CHASE BANK EAST BLOOMINGTON

ISSUE	DATE	DESCRIPTION
A	02/19/2025	ISSUED FOR DRC REVIEW

SITE PLAN

C200

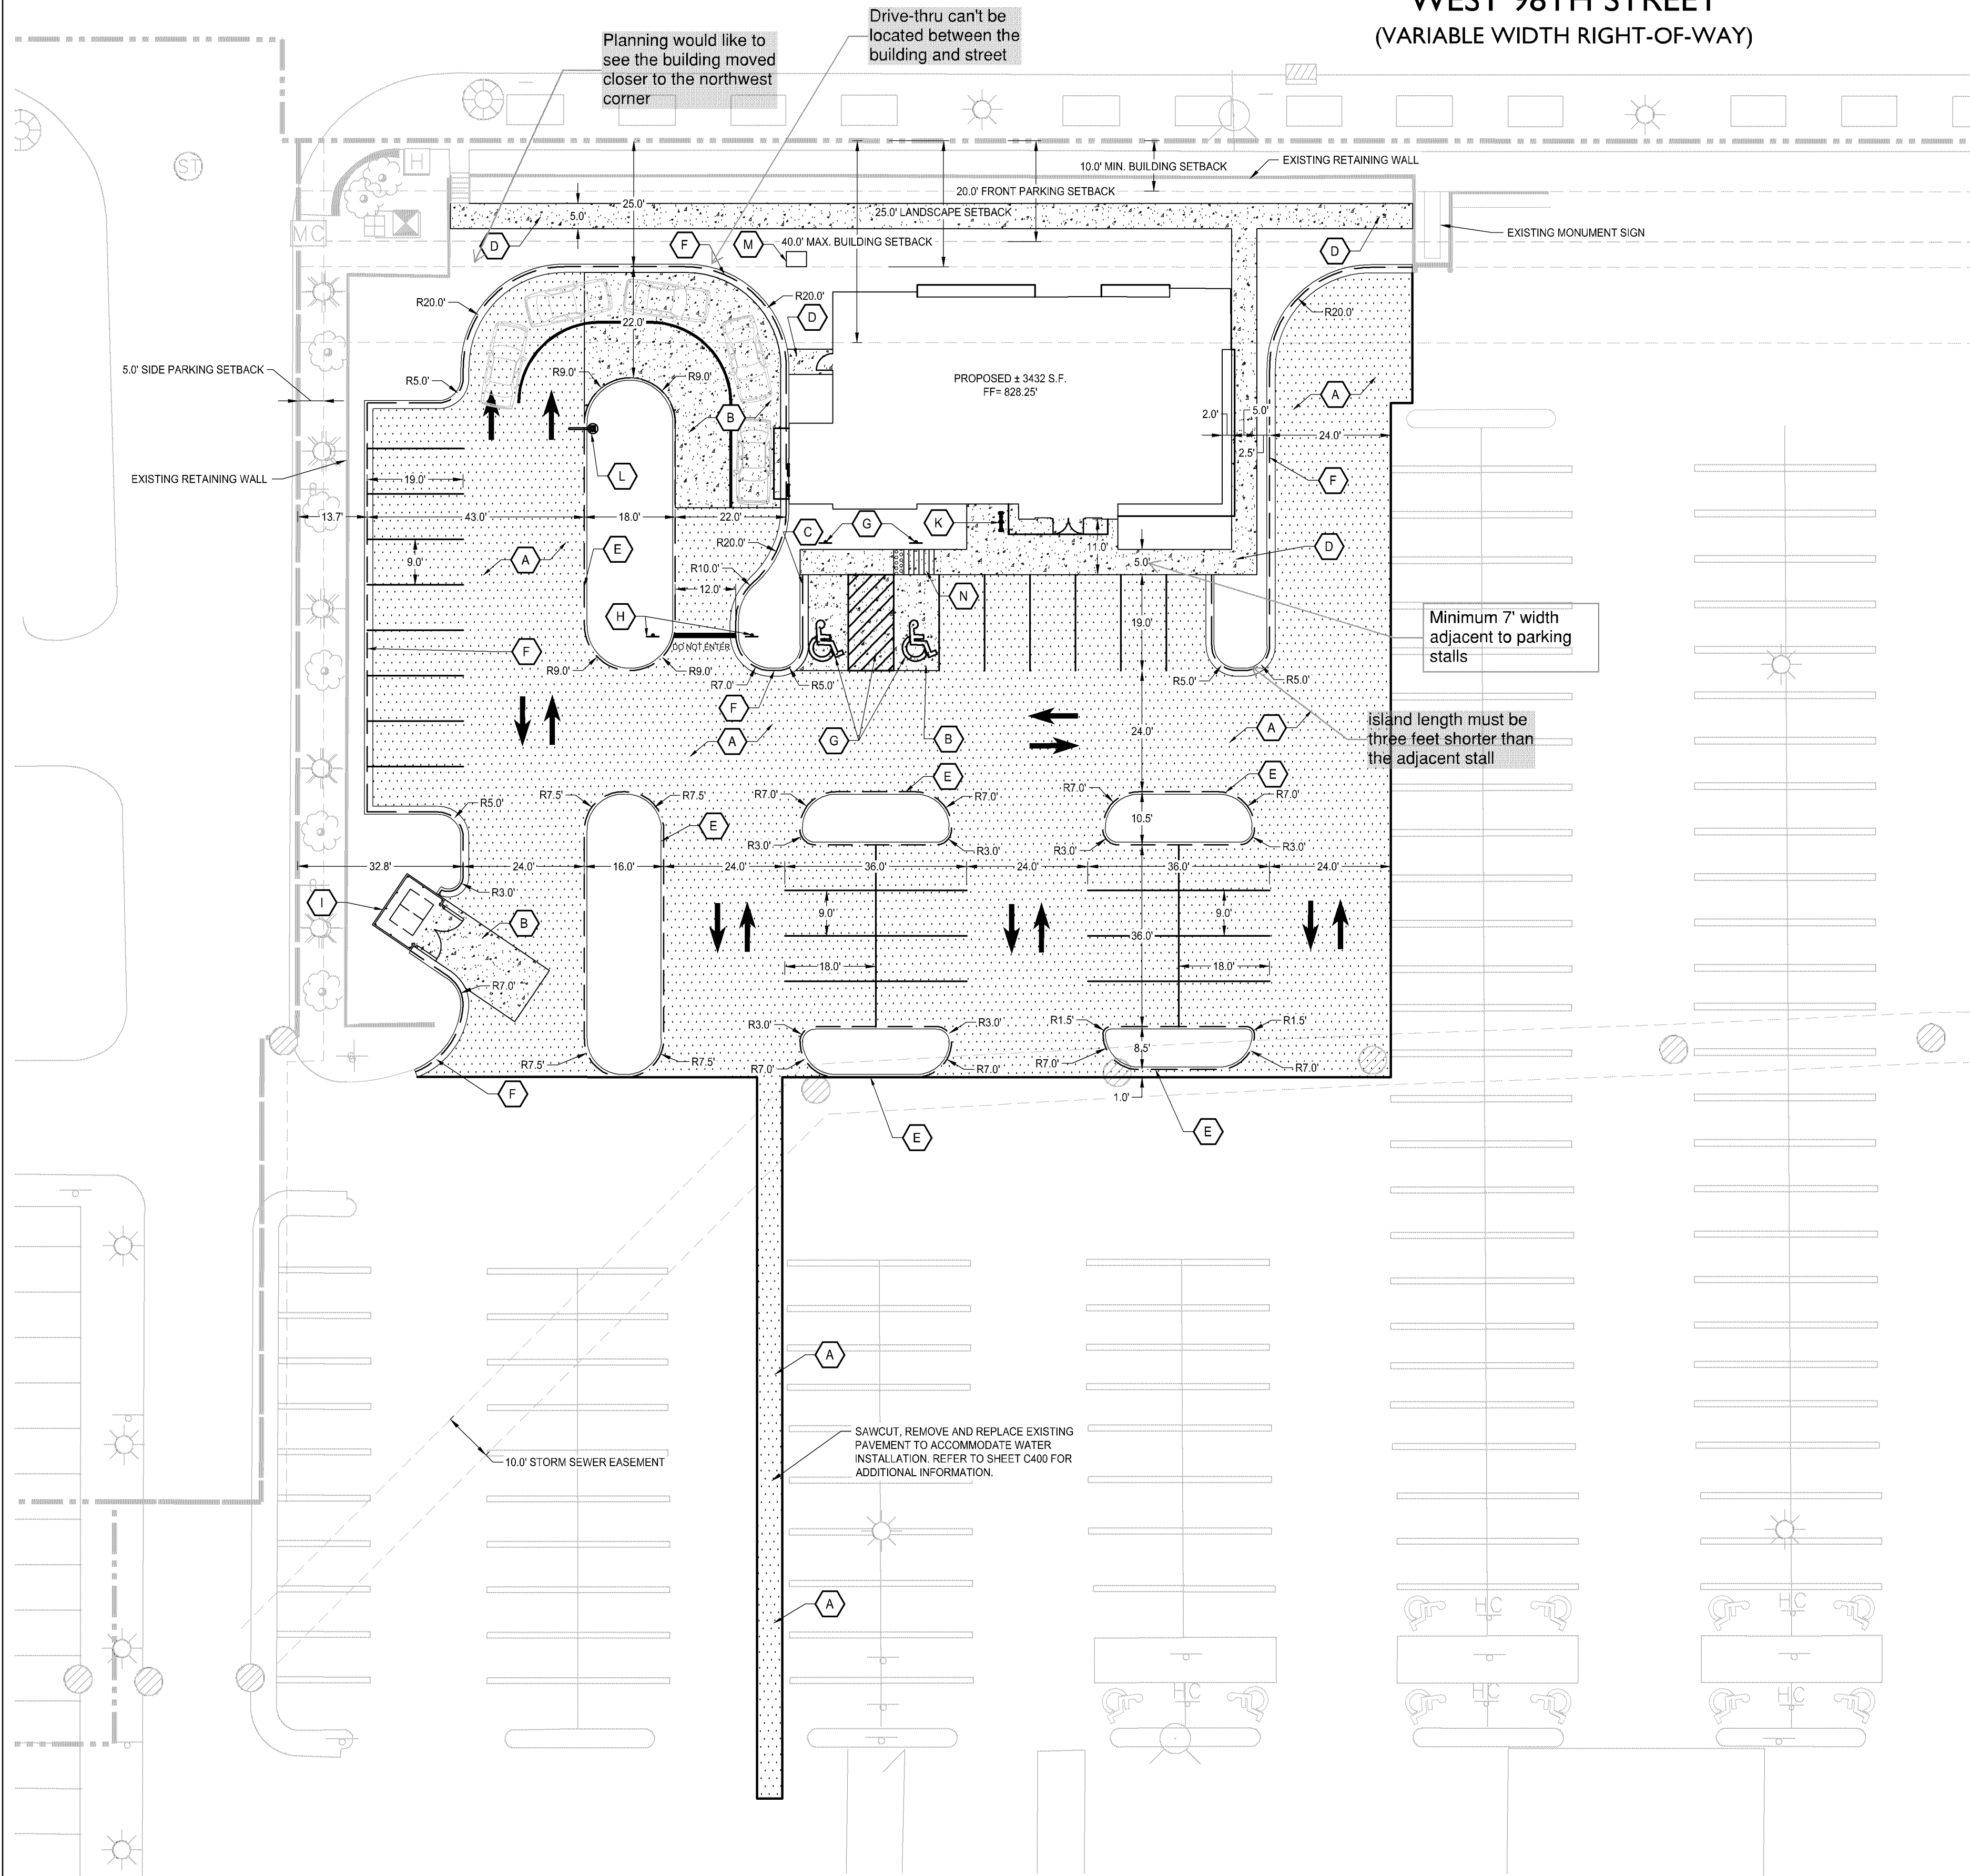
All emergency vehicle access lanes shall support a minimum 40 tons.

Provide adequate turning radius to accommodate BFD L3 for all emergency vehicle access lanes.
